Submission to the Valley of the Winds
Wind Farm (SSD-10461) - NSW
Independent Planning Commission (IPC)

From: Amber Pedersen, Burrendong SOS
Representative and Co-Secretary of CWO
REZist Inc.

10/4/25

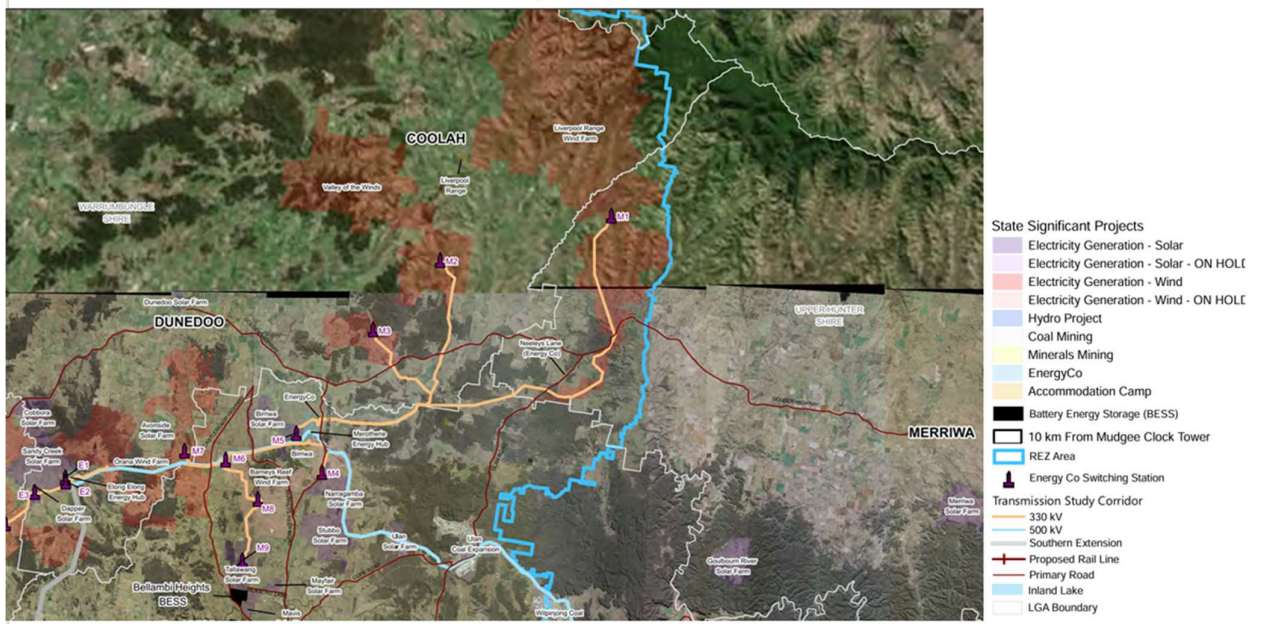
This is disingenuous and dismissive of the real cumulative visual impacts on local residence and the landscape.

This statement does not align with the recognised visual impacts of turbines on landscape values as outlined in the VAB, 2016.

Figure 12 Preliminary Assessment Tool 2: Multiple Wind Turbine (Map Source: Six Maps)

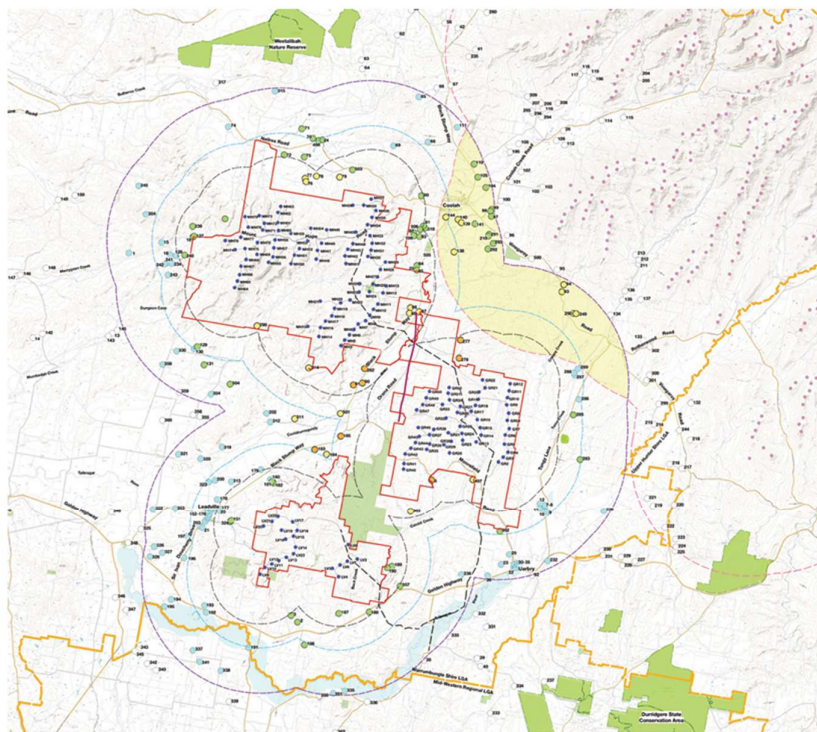
Working farming families will be forced to see these industrial-scale turbines across their entire properties—not just from their homes—yet visual mitigation is limited to the residential curtilage and potentially only to screen a turbine viewed within 4.95km of a residence. If approved without fair compensation, these turbines will become a daily reminder to the community of how they've been failed by Government and treated as second-class citizens. How is it that offshore REZs require a 20km setback, while residents in the Central-West Orana REZ are expected to live just 2km—or even less—from 250m high turbines dominating ridgelines above their homes?

The Department's claim that the project is "consistent with being in a REZ" does **not** justify ignoring cumulative visual impacts. The REZ boundary was established in 2020 without notification, consultation, or consent—contrary to legislative requirements. Even EnergyCo has acknowledged that residents will be living in a "modern-day power station." Being inside a REZ does not exempt proper assessment or mitigation of these serious landscape and visual impacts. Landowners deserve fair visual screening out to 12km to address the reality of being surrounded by industrial-scale infrastructure and in attempt to attain some level of "social licence" with the community
